**La Jolla Shores Planned District Advisory Board (LJSPDAB)  
APPLICANT PROJECT INFORMATION FORM**

### **7717 SIERRA MAR DRIVE – PROPOSED REMODEL AND ADDITION**

# HARRIS REMODEL AND ADDITION

Building Construction Plans PRJ-1106800.pdf

**PLOT PLAN**  
1" = 20'-0"

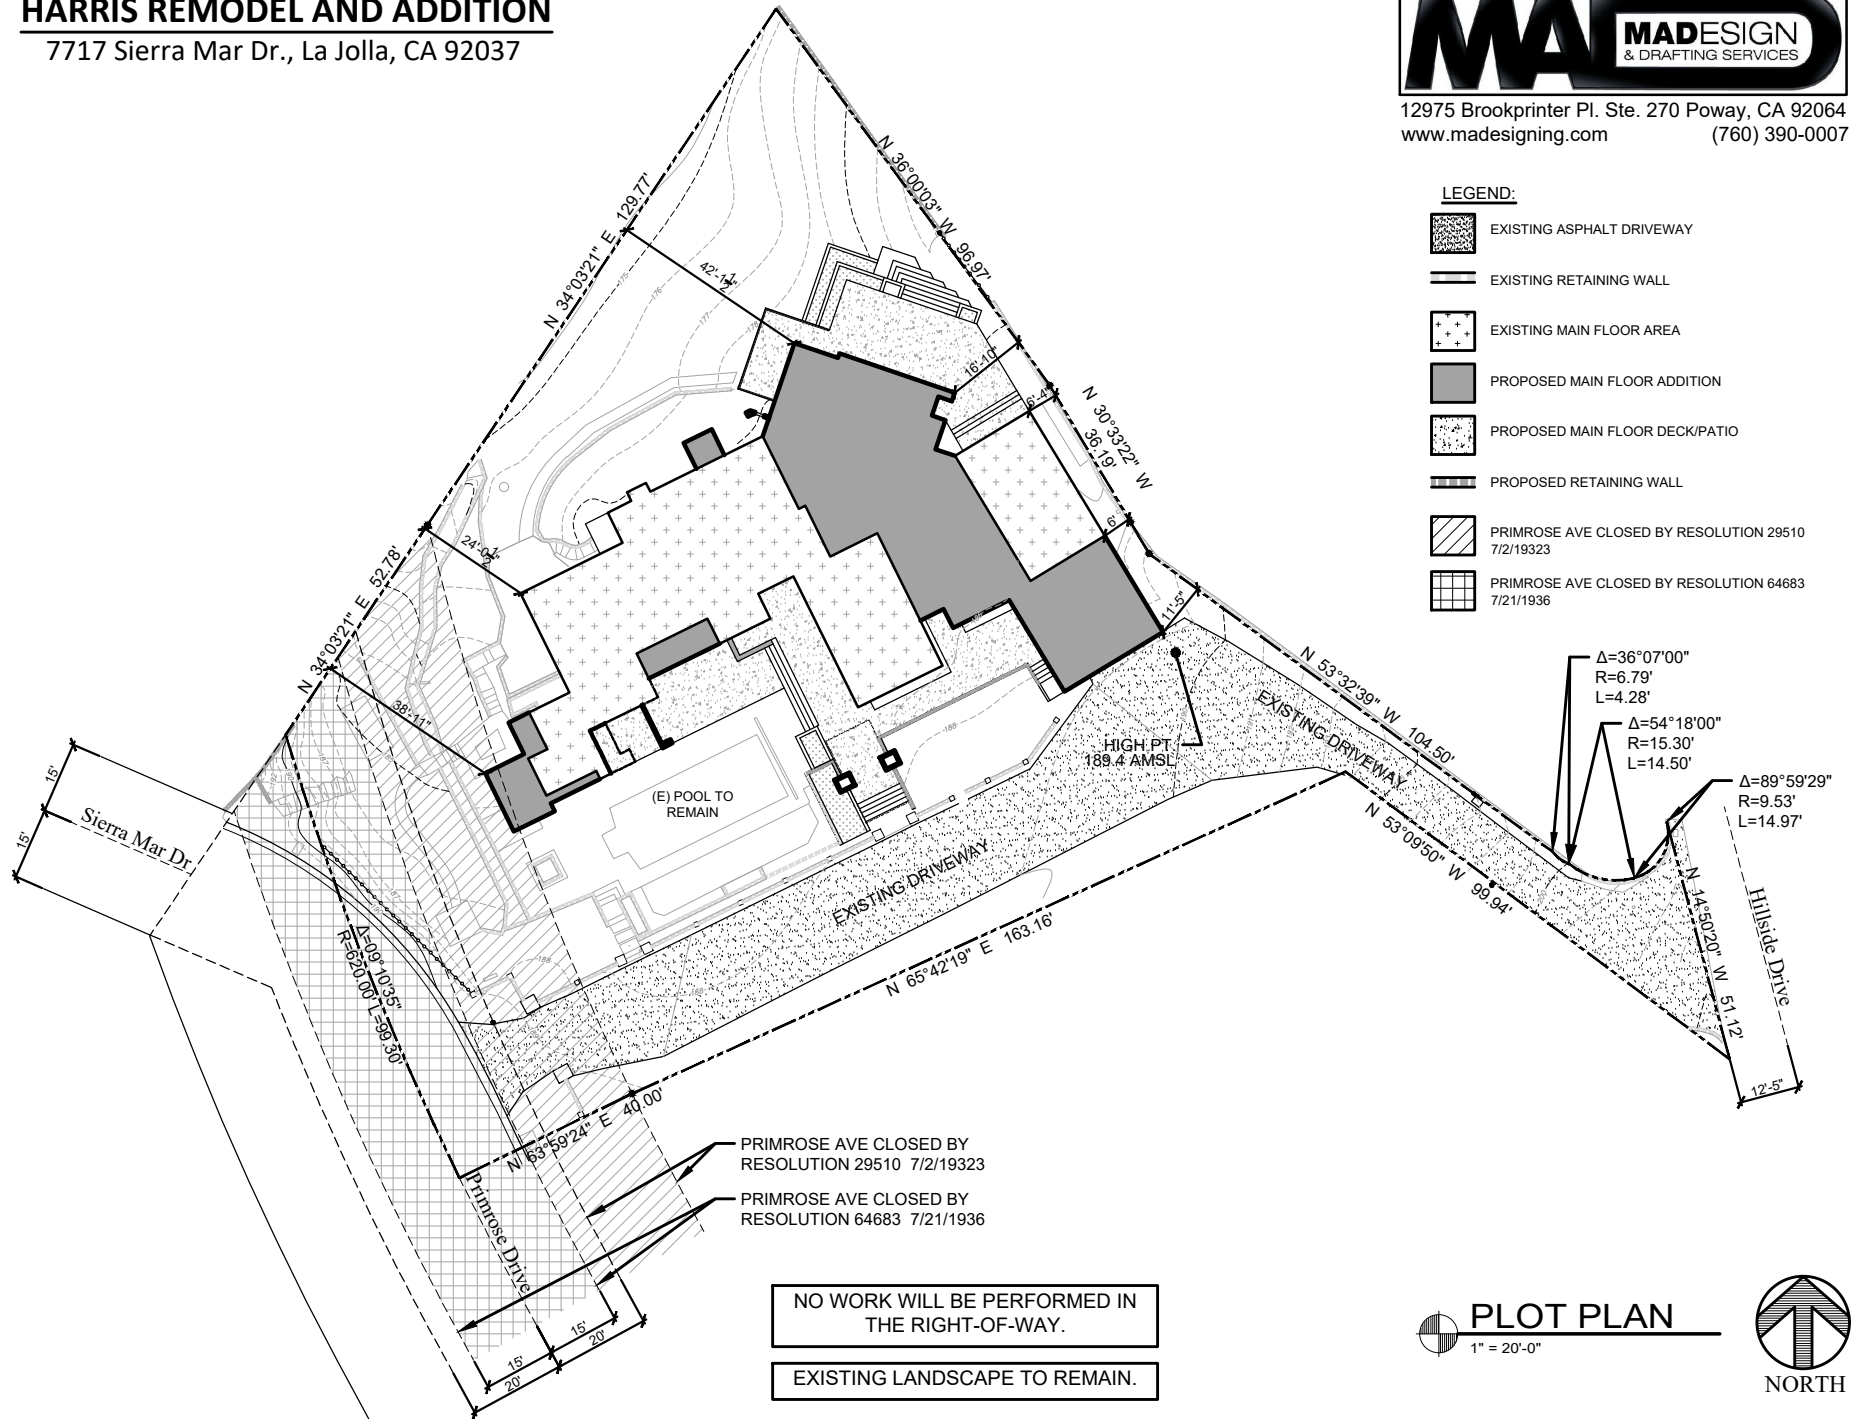
Records indicate there are drainage easements going through this property. Show exact location with dimensions of all existing easements.  
Please contact our Records Department at DSDRCD@SANDIEGO.GOV to conduct further research.

Plot Plan: Please verify / reference / provide a 1-hour construction detail on the underside if overhang is 5 feet or less from the property line. Section R302.1

## PROPOSED MAIN FLOOR PLAN

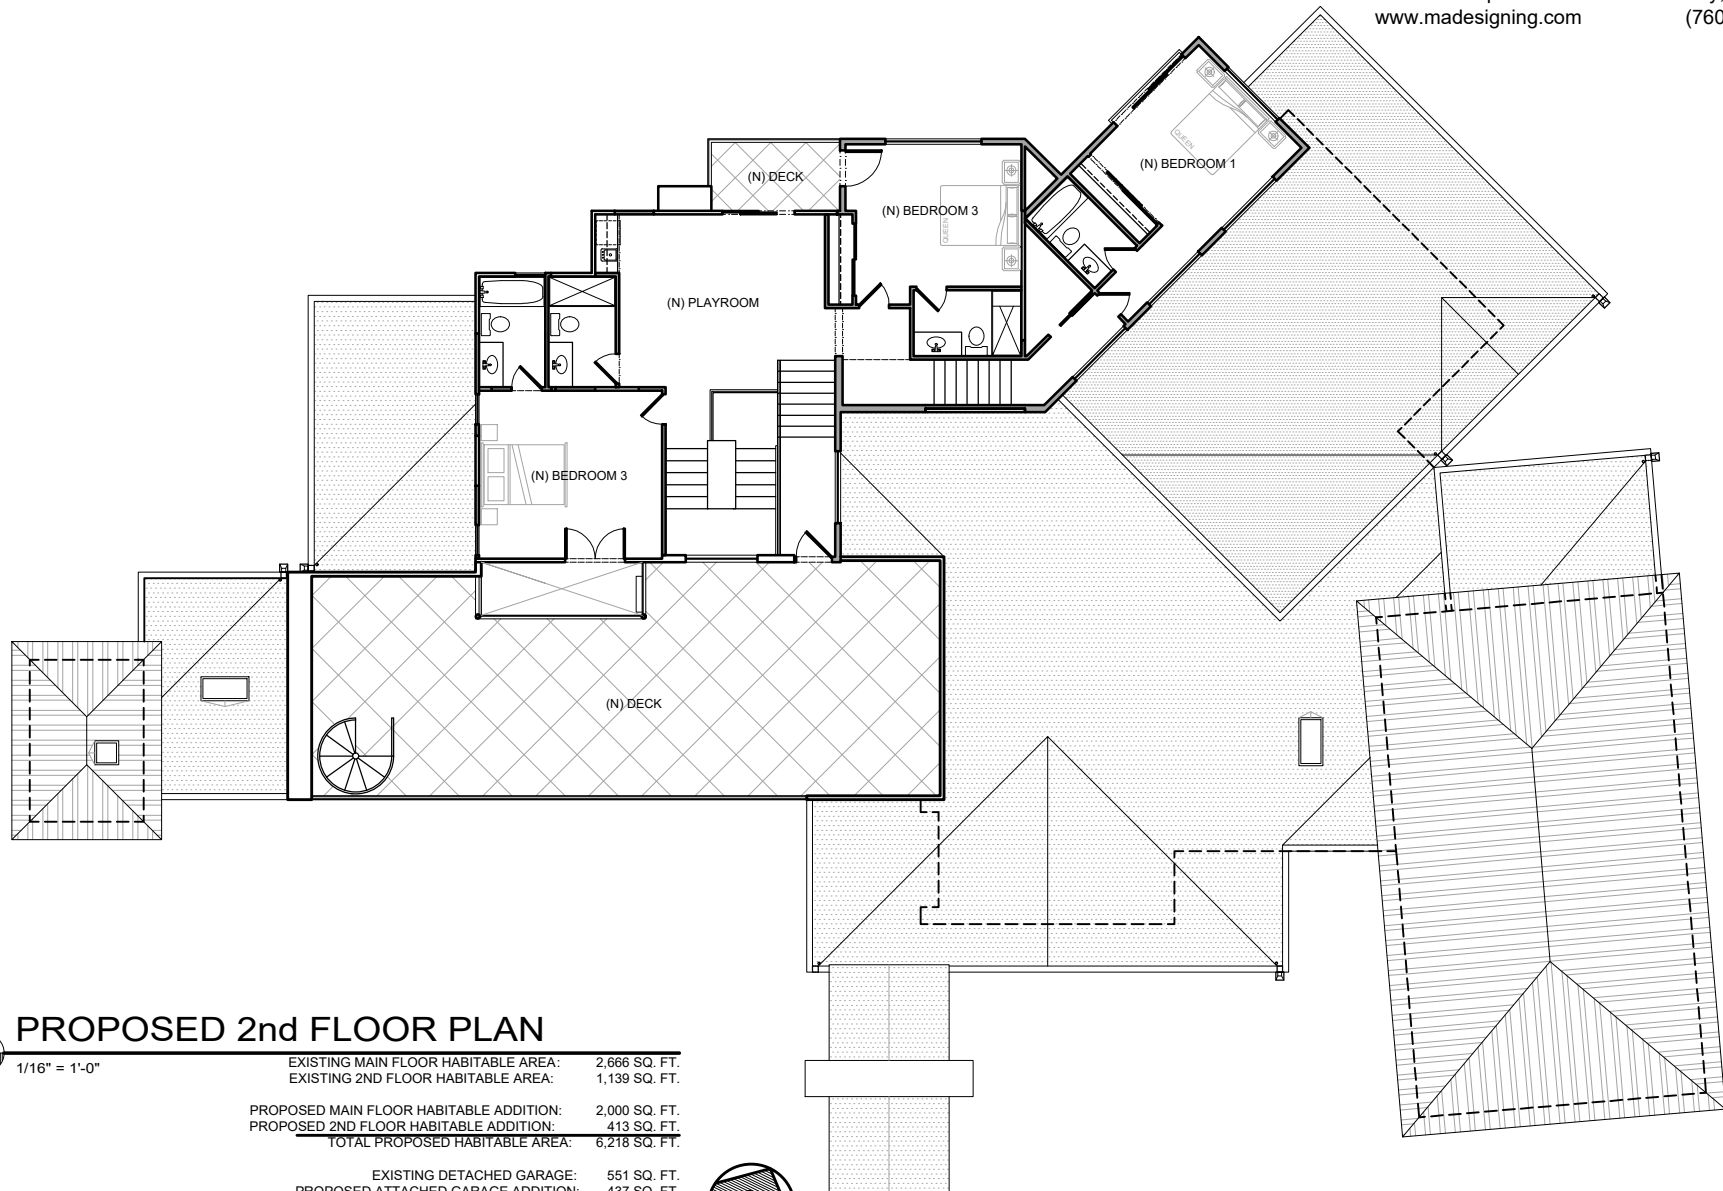
Newly installed kitchen range hood will require mandatory verification by a HERS rater. Add the kitchen range hood to the HERS Feature Summary of the T-24.

Cross reference U-factor and SHGC from T-24 Energy Calculations to Floor plan.

Please indicate in the plans which method will be used to meet the requirements for ventilation for indoor air quality (IAQ). Clearly identify the dedicated source and note the ventilation rate (cfm) that will be used to achieve the requirements of whole-building ventilation.

Please show the kitchen range and hood on the proposed floor plan and indicate that the kitchen range hood capacity for the SFR should be a minimum of 110 CFM if the hood is over electric range, or 180 CFM if hood is over natural gas range.

Show Water Heater model no. on plans, information on plans must match that or CF1R/ Water Heaters table.

Show Heating/Cooling Unit location and specifications on plans. Information on plans must match that or CF1R/ HVAC-Heating Unit Types table, HVAC-Cooling Unit Types table and HVAC-Heat Pump Types.

Show the size, routing, length, and termination of the vent for the Nany Suite clothes dryer.

Please show on plans that the dryer vent is at least 3' from exterior doors and exterior windows.

Show a minimum 22" by 30" attic access opening with 30" minimum vertical clearance at the opening. [CRC R807.1]. Show each location with dimensions on plans.

## FRONT / SOUTHEAST ELEVATION

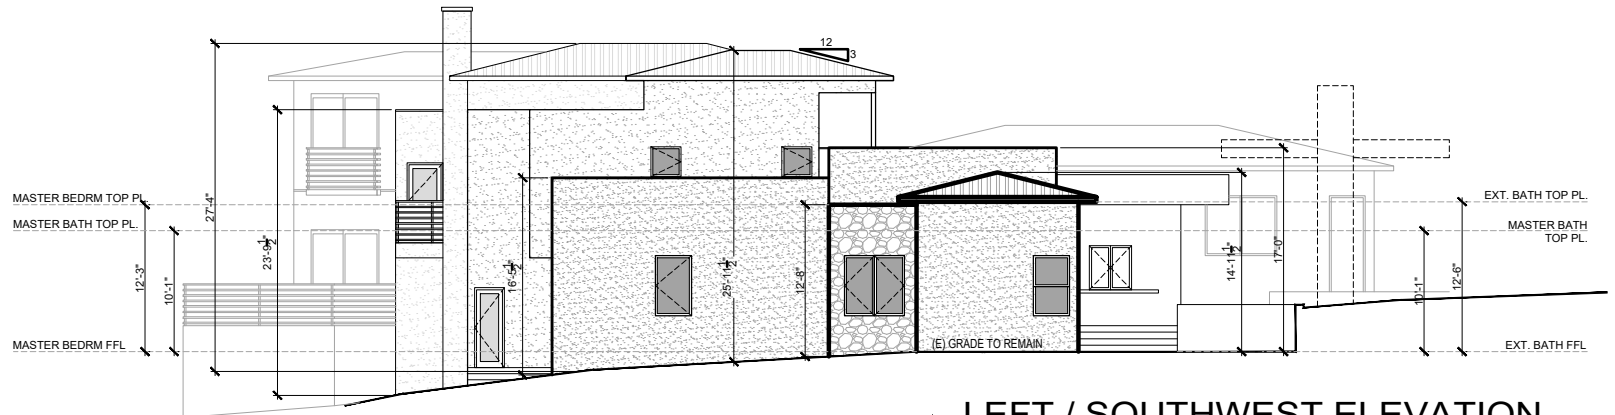
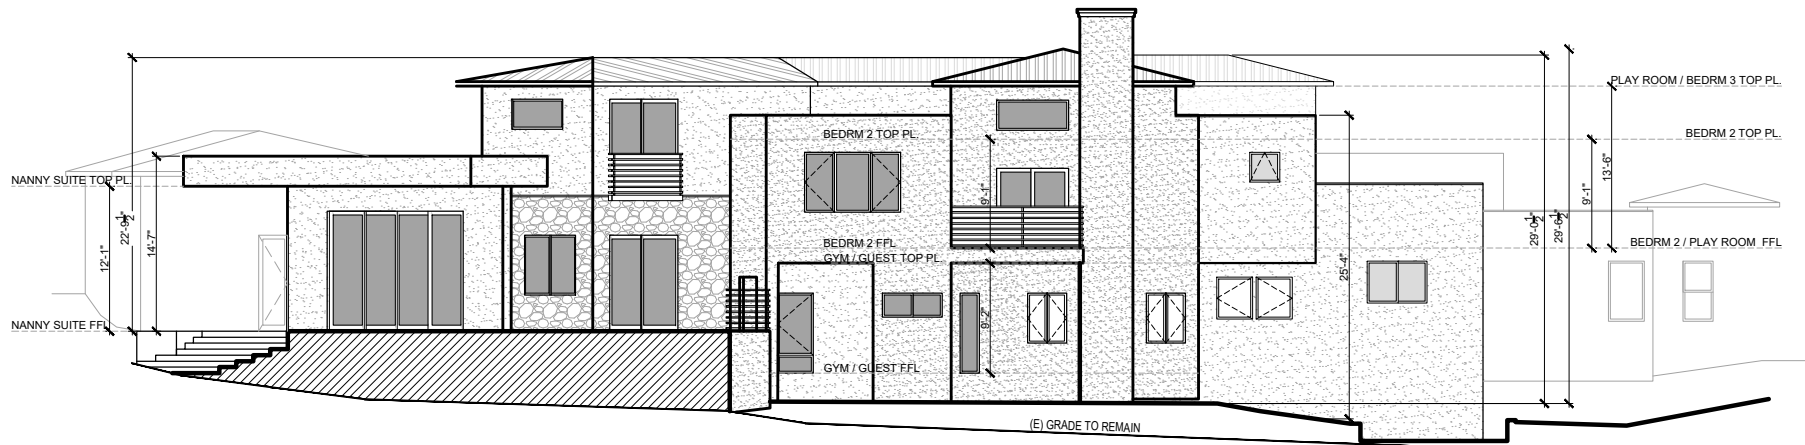
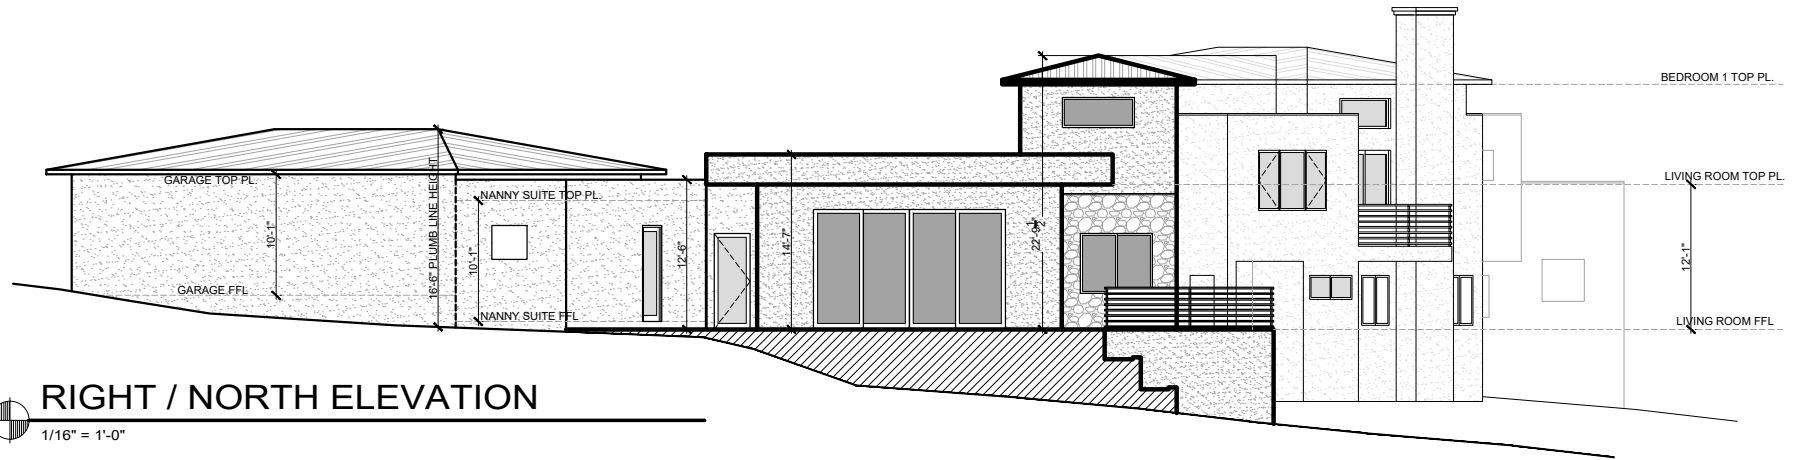
Show, label and dimension the plumb line height measurement on all elevations.

Show, label and dimension the Overall Height Measurement on all elevations. The overall structure height is measured from the lowest point of existing grade or proposed grade within 5 feet of the structure's perimeter (building wall, balcony, bay window, or similar architectural projection) or at the property line, whichever is closer, to the highest point of the structure, projected horizontally to directly above this lowest point of grade. The overall structure height shall not exceed the maximum permitted structure height of the applicable zone plus an amount equal to either the maximum grade differential within the structure's footprint or 10 feet, whichever is less. The structure height shall not exceed the maximum allowed by the applicable zone at any one point.

Show, label and dimension the Coastal Height Limit measurements on all elevations.
